SUBJECT: Responds to final environ rept review questions. Hydrologic engineering questions & terrestrial & aquatic resource questions will be addressed in near future.

SHEARON HARRIS NUCLEAR POWER PLANT  
UNIT NOS. 1 AND 2  
DOCKET NOS. 50-400 AND 50-401  
ENVIRONMENTAL REPORT REVIEW QUESTIONS RESPONSES

Carolina Power & Light Company's response to the final Environmental Report (ER) review questions numbered 240.1, 240.2, 240.10, 290.5, 290.7, 291.7, 291.8, 291.9 and 291.13 (partial) is attached. This response supplements our letter of June 3, 1982, and completes our response to the ER review questions with the exception of certain Hydrologic Engineering questions and the reservoir reanalysis dependent portions of Terrestrial and Aquatic Resource questions 291.13 and 291.15 as discussed below.

FIGURE 240.10-1  
 SEDIMENT DISCHARGE RATING CURVE  
 BUCKHORN CREEK NEAR CORINTH, N.C.

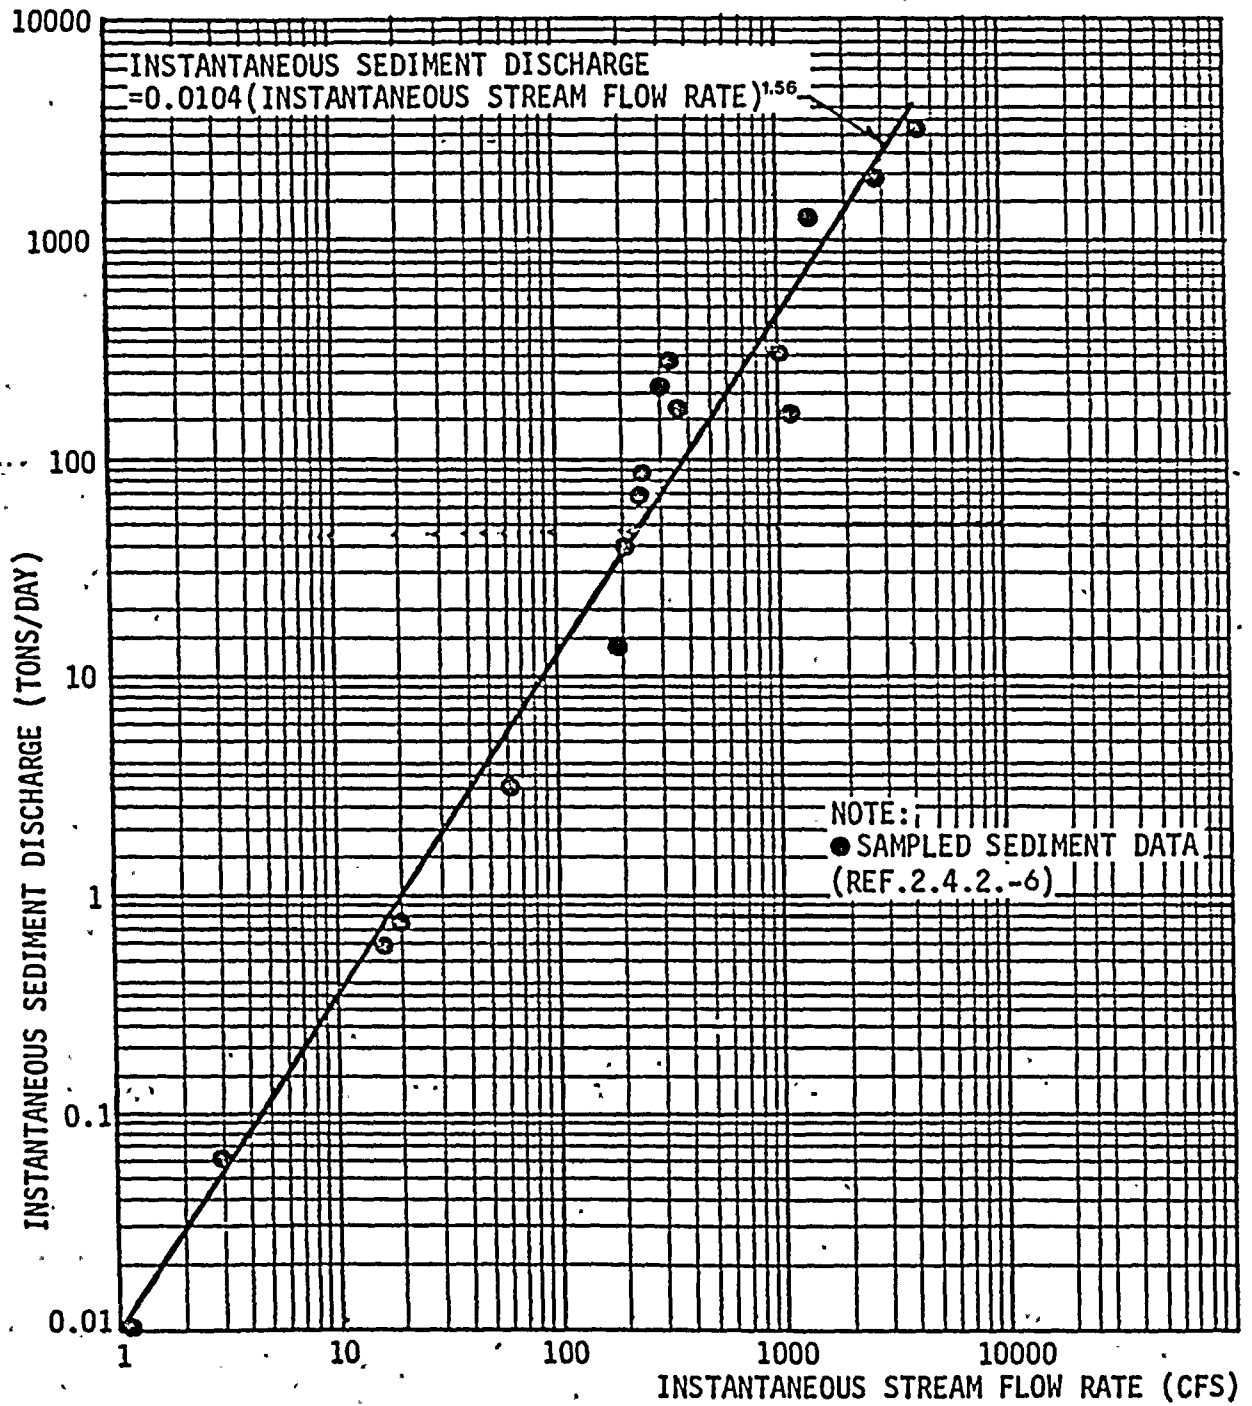
Describe in greater detail the sediment rating formula used to calculate sediment inflow to the main reservoir. State the number of data points used to derive the relationship, the range of flows these data points represent, and the distribution by season of the data points. If the number of data points is relatively small, provide a plot of the data and the line of best fit. Otherwise, provide the pertinent parameters of the regression analysis including the correlation coefficient and the standard error of estimate.

To estimate the effect of sedimentation on the Main Reservoir bottom and shoreline configuration, the following sediment rating formula was deduced from the sediment sampling data of Buckhorn Creek near Corinth, North Carolina (D.A = 74.2 sq. miles) (Reference 2.4.2-6 of the SHNPP ER) by a regression analysis:

The sediment discharge sampling record used is summarized in Table 240.10-1, attached. This record consists of 17 data points. The instantaneous streamflow rates associated with these samplings range from 1.1 to 4410 cfs. The seasonal distributions of these data points are six in winter, three in spring, five in summer and three in fall. On Figure 240.10-1, these data points are shown with the rating curve representing the above formula. The parameters associated with the regression analysis are  $r = 0.987$  and  $S = 0.301$  in which  $r$  is the correlation coefficient and  $S$  is the standard error of estimate.

Conservatively, a constant value of  $IPQ/Q = 2.21$  is used. This value represents the maximum ratio in the 1972 to 1977 streamflow record (Reference 2.4.2-6 of the SHNPP ER) and occurs during the flood of February 2, 1973 having a peak discharge of 6920 cfs, while the corresponding daily streamflow is 3130 cfs. The above formula then becomes:

By assuming 100 percent sediment trap efficiency for the Main Reservoir, the total volume of sediment deposit is estimated to be about 460 ac. ft., accumulated over forty years of plant life. Since this amounts to only 0.7 percent of the reservoir capacity at the normal operating level, any noticeable effect of sedimentation on the shoreline and bottom configuration will be localized.

Figure 1 SHNPP wildlife management areas

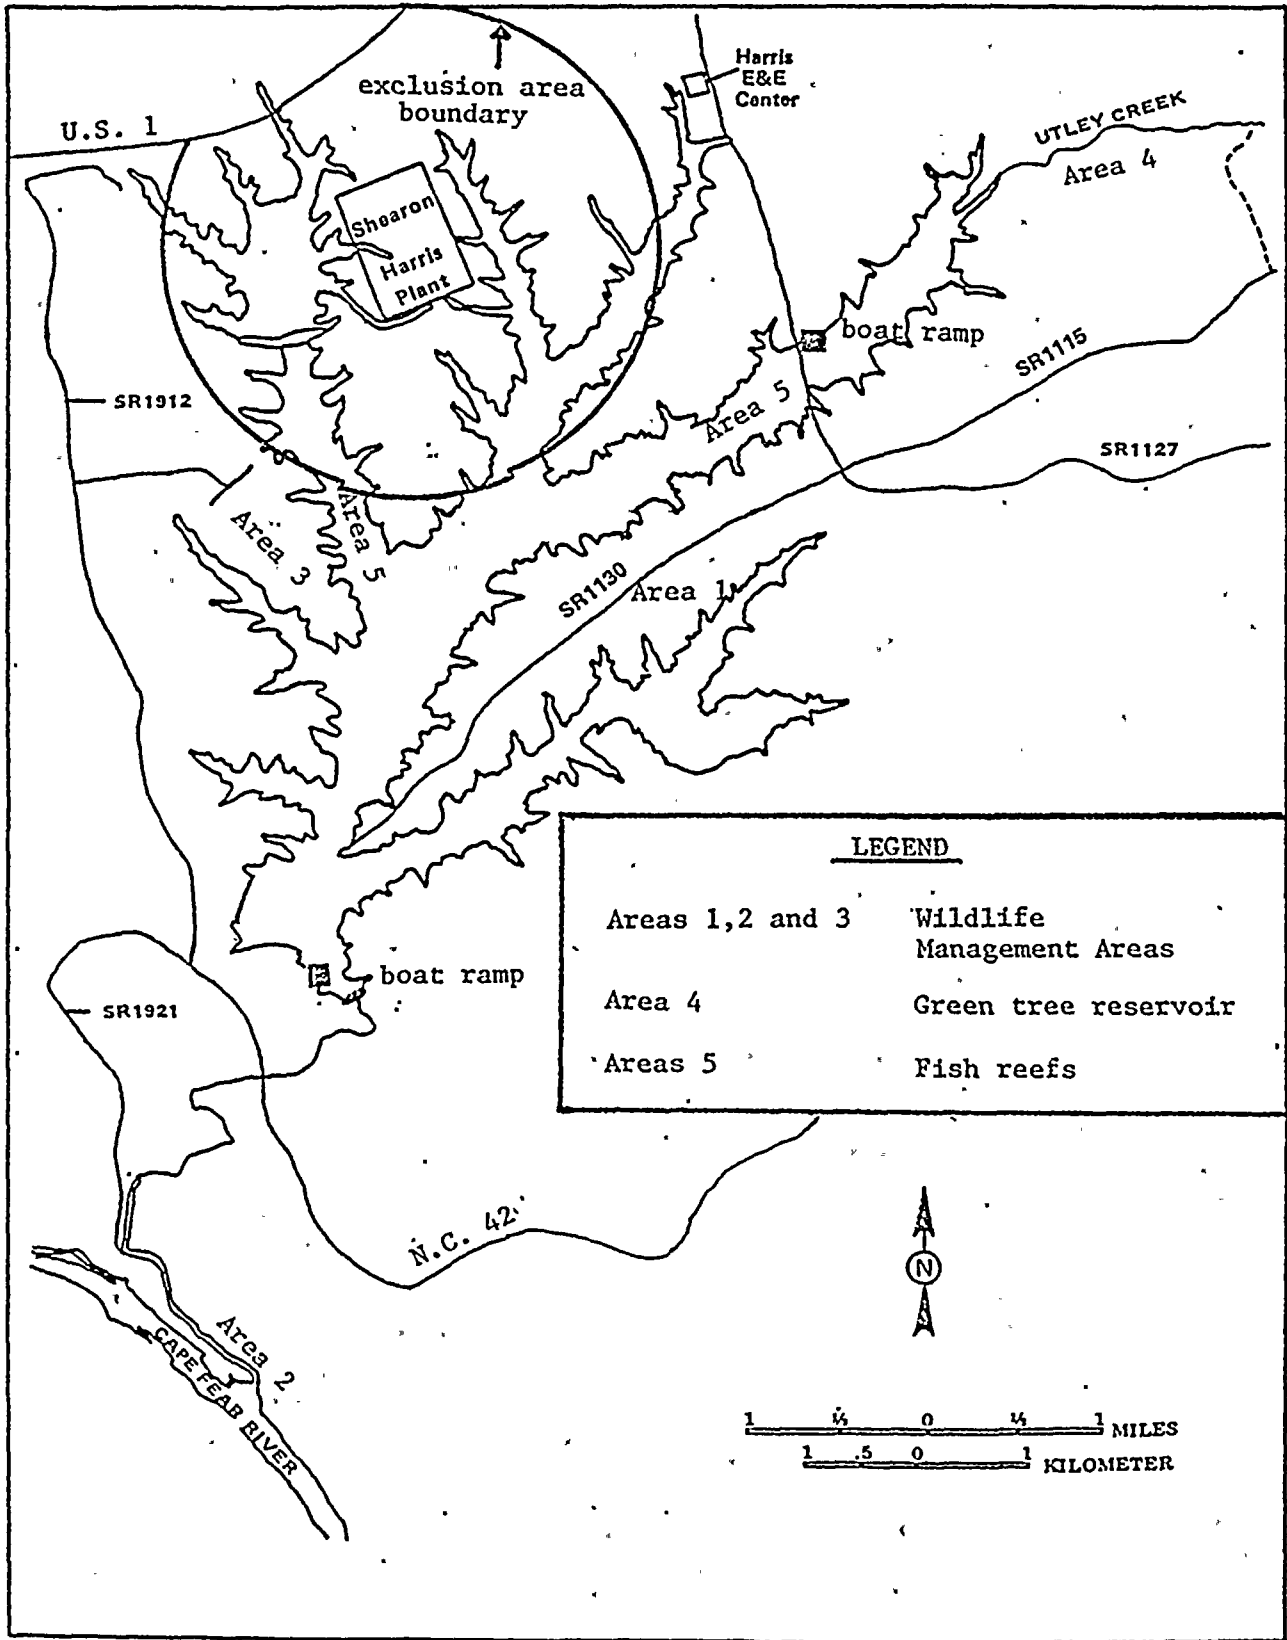
Provide for NRC review a copy of the proposed site fish and wildlife management plan.

A copy of the SHNPP fish and wildlife management plan is provided in Attachment 1.

The wildlife management plan will provide improved wildlife habitat on the SHNPP site and will include the establishment of wildlife management areas. Five areas that have high wildlife productivity potential are (Figure 1):

CP&L will provide boat ramp facilities to assure adequate public access to the reservoir (Figure 1). One ramp already constructed near the main dam for Company use may be modified for public use. Some road improvement and a larger parking area would be required. A second public access area, possibly at the Wake SR 1127 crossing of the reservoir, will also be provided. These areas are next to state maintained roads and would not require passage through the plant site or the exclusion area boundary.
